Functional Differences Between MSC8101 (Mask 2K42A) and MSC8103 (Mask 2K87M)

This document describes the differences between MSC8101 mask set 2K42A and MSC8103 mask set 2K87M. These differences include:

Figure 5. MSC8103 Clock Functional Block Diagram for 2K87M Mask Set

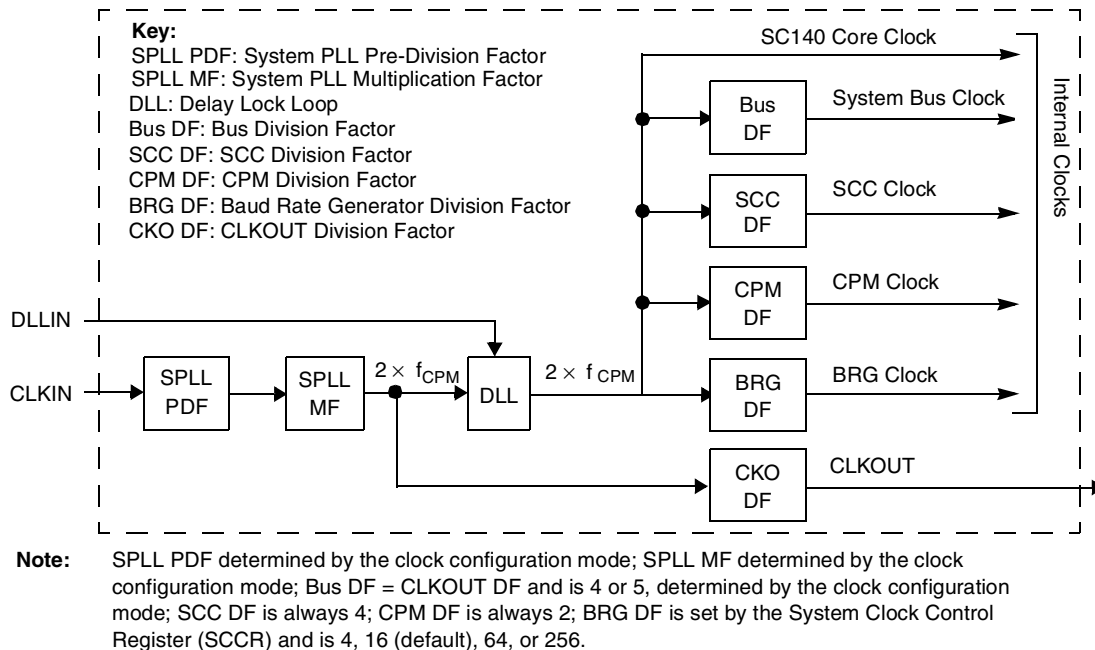
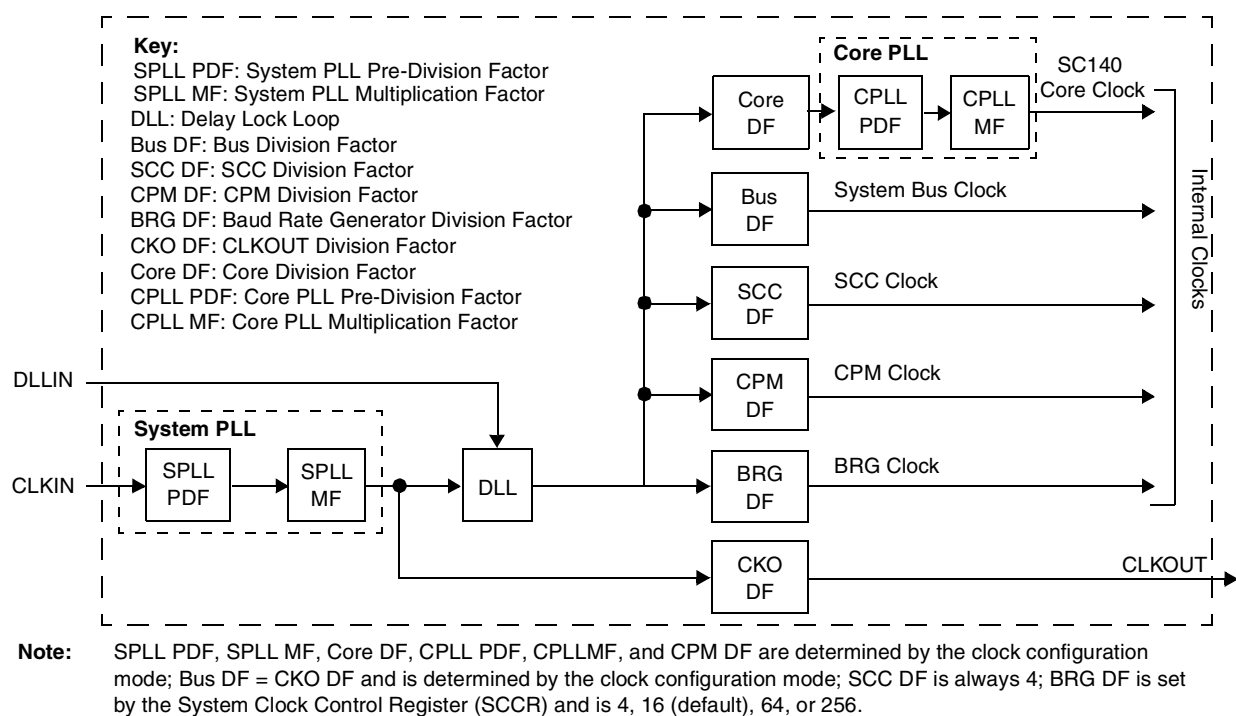
Figure 4 shows the functional block diagram for the 2K42A mask set. The 2K42A mask set contains an internal system phase-lock loop (SPLL)

Figure 5 shows the functional block diagram for the 2K87M mask set. The 2K87M mask set contains an internal system phase-lock loop (SPLL) and a core phase-lock loop (CPLL).

Figure 10. HDI16 Host Request Structure

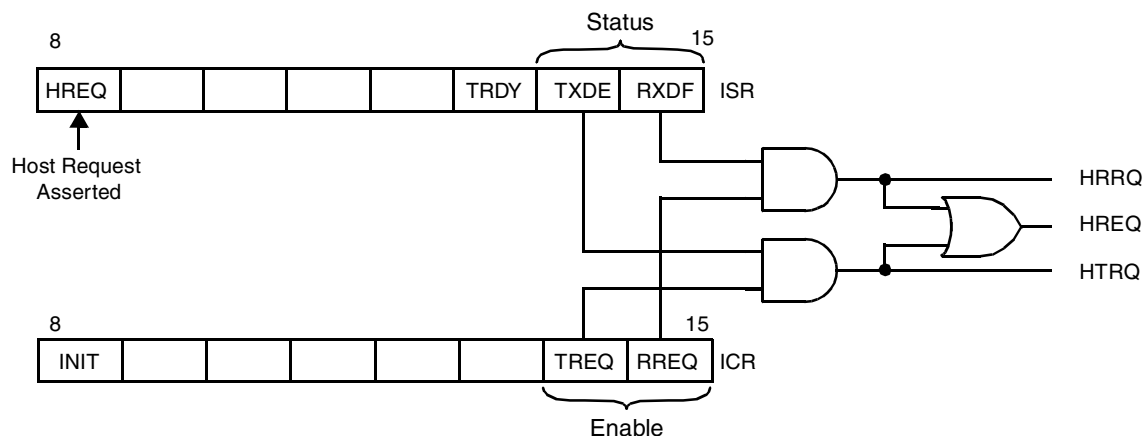
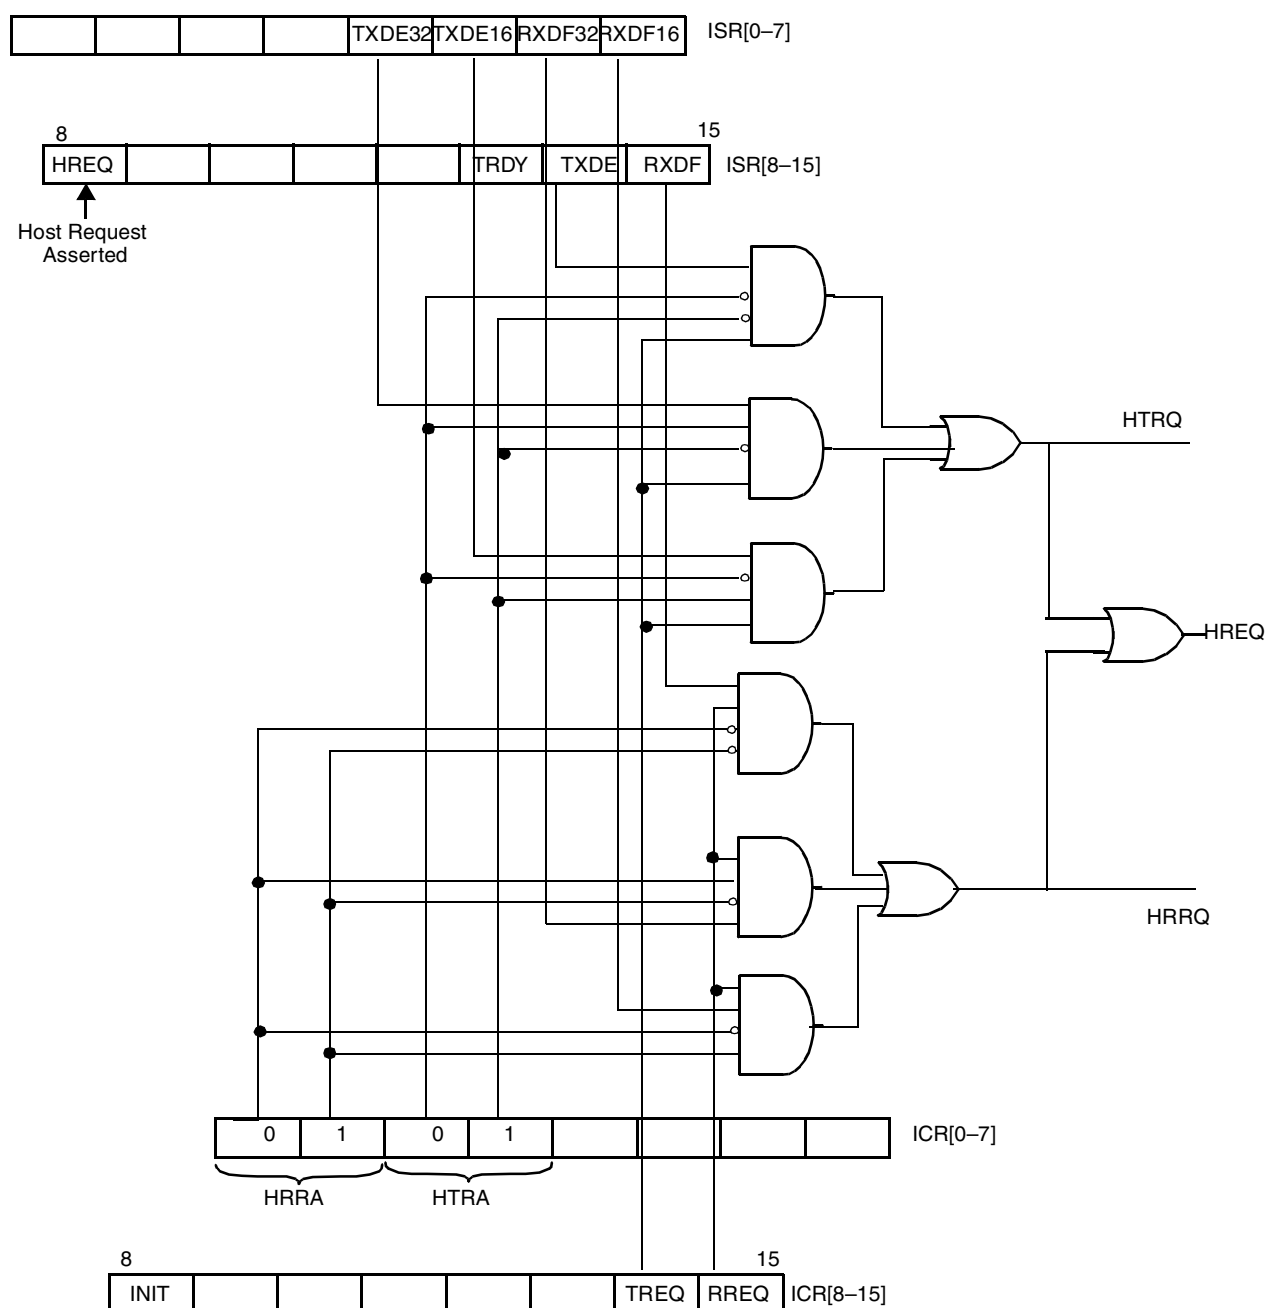
9.3.1 2K42A Mask Set HREQ Logic

9.3.2 2K87M Mask Set HREQ Logic

When HREQ is connected to the host processor interrupt input, the HDI16 asserts HREQ to request service from the host processor. HREQ is asserted according to the programming of ICR[HTRA] and the status bits TXDE, TXDE16, and TXDE32 when ICR[TREQ] is set, or according to the programming of ICR[HRRA] and the status bits RXDF, RXDF16, and RXDF32 when ICR[RREQ] is set, as **Figure 10** shows. The programming of HRRA or HTRA chooses the status bit, and depending on its value, HREQ is asserted or deasserted.

Figure 12. 2K87M Mask Set 32 KB Dual-Port RAM Memory Map

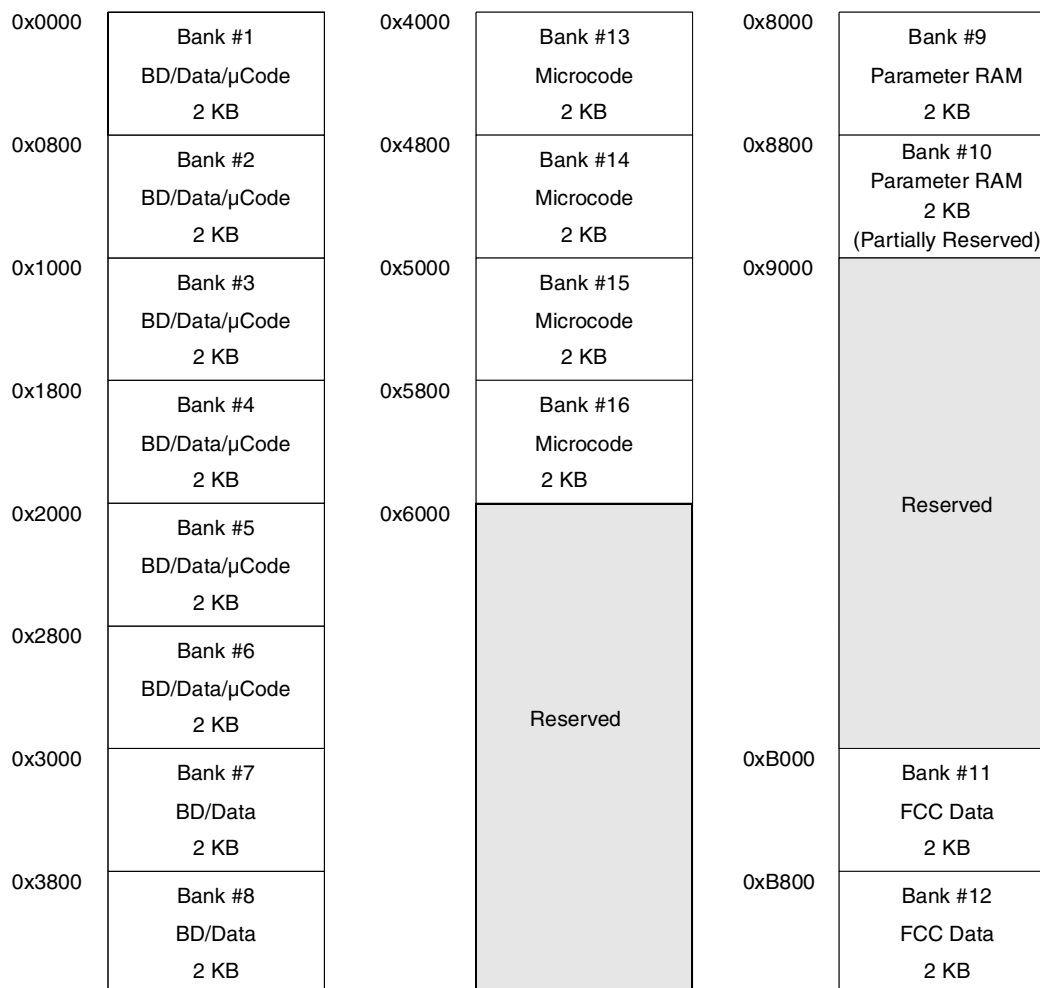
Figure 11 shows the MSC8101 2K42A mask set memory map of the dual-port RAM.

Figure 12 shows the MSC8103 2K87M mask set memory map of the dual-port RAM.
